URGENT FIELD SAFETY NOTICE

Ref No: PFSN 9180 Electrolyte Analyzer - wrong arrow direction for Calcium results on system display SBN-CPS-2020-014

Date: 18/12/20

9180 Electrolyte Analyzer - wrong arrow direction for Calcium results on system display

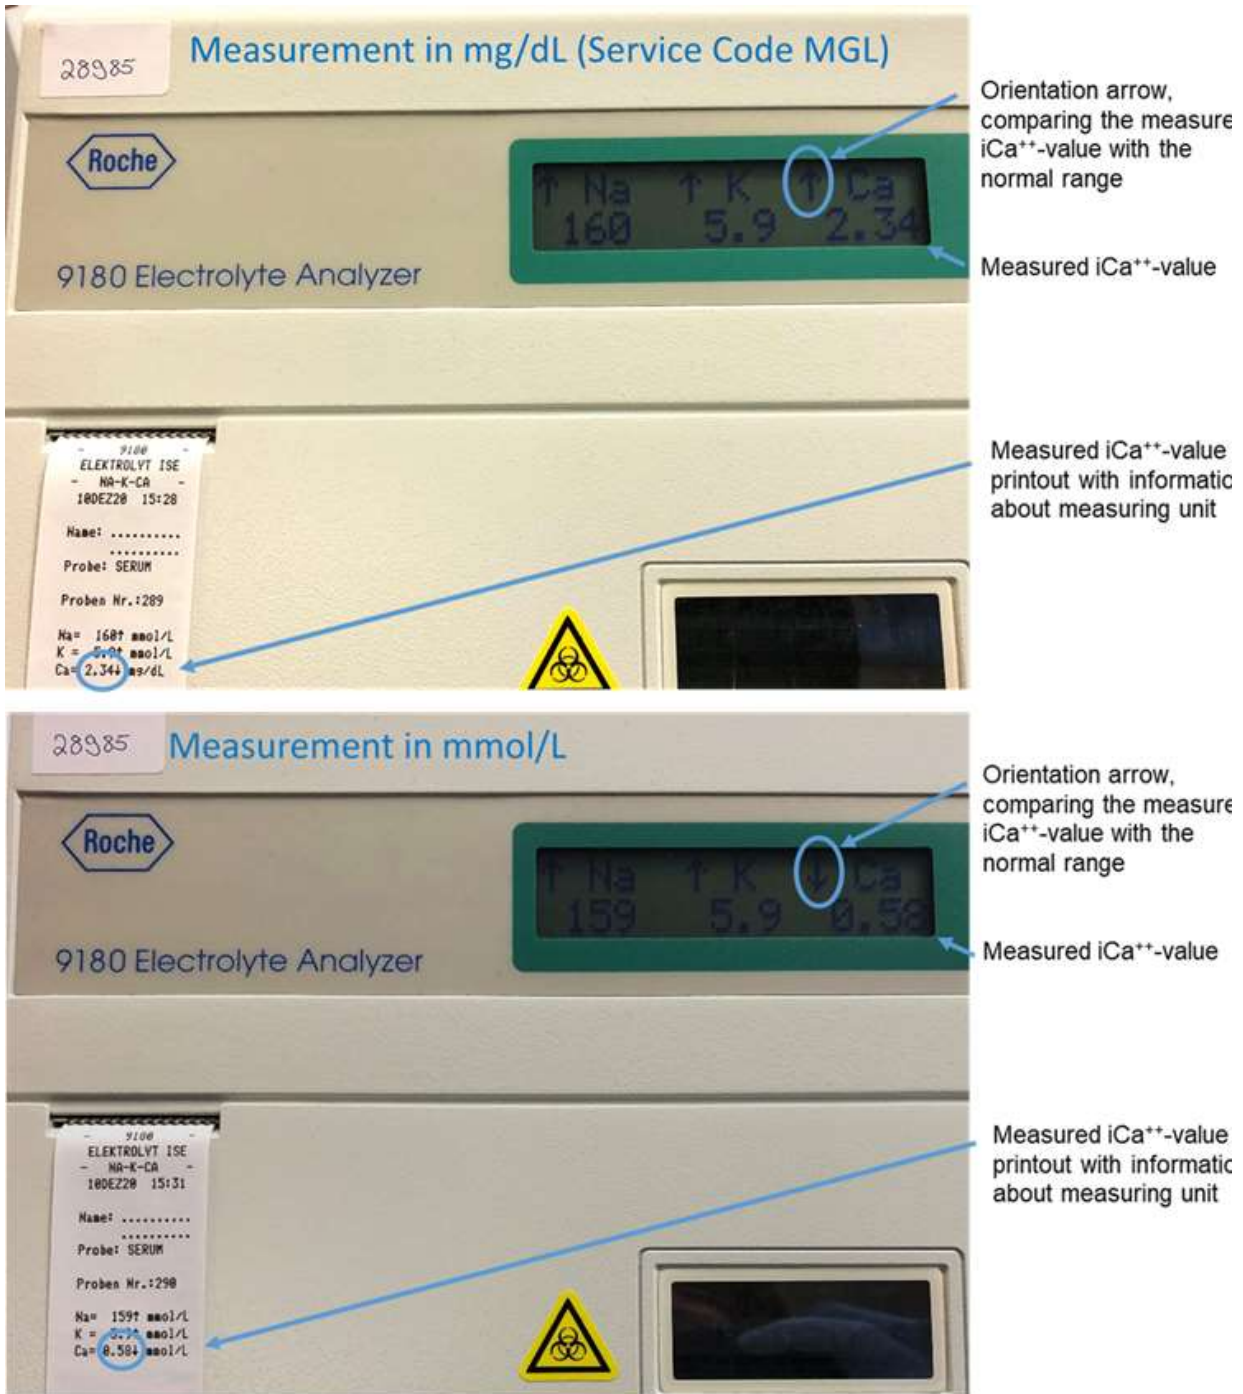
During internal verification studies the following possible scenario was observed: if the unit for iCa^{++} is set to mg/dL (Service Code MGL configured) and a measured iCa^{++} -value is lower than the normal range, an upward arrow is shown on the display instead of a downward arrow independent of serial number or software version.

The displayed numeric result is correct and on the printout result and arrow direction are shown correctly.

Only iCa^{++} is affected.

Make sure that iCa⁺⁺ values are reported in mmol/L instead of mg/dL or contact your Roche Services representative.

The guiding arrow on the display can be wrong if the unit for iCa⁺⁺ is set to mg/dL (Service Code MGL configured) and if a measured iCa⁺⁺-value is lower than the normal range.

If you use the unit mg/dl for iCa⁺⁺, always use arrow information from the printout and not from the display.
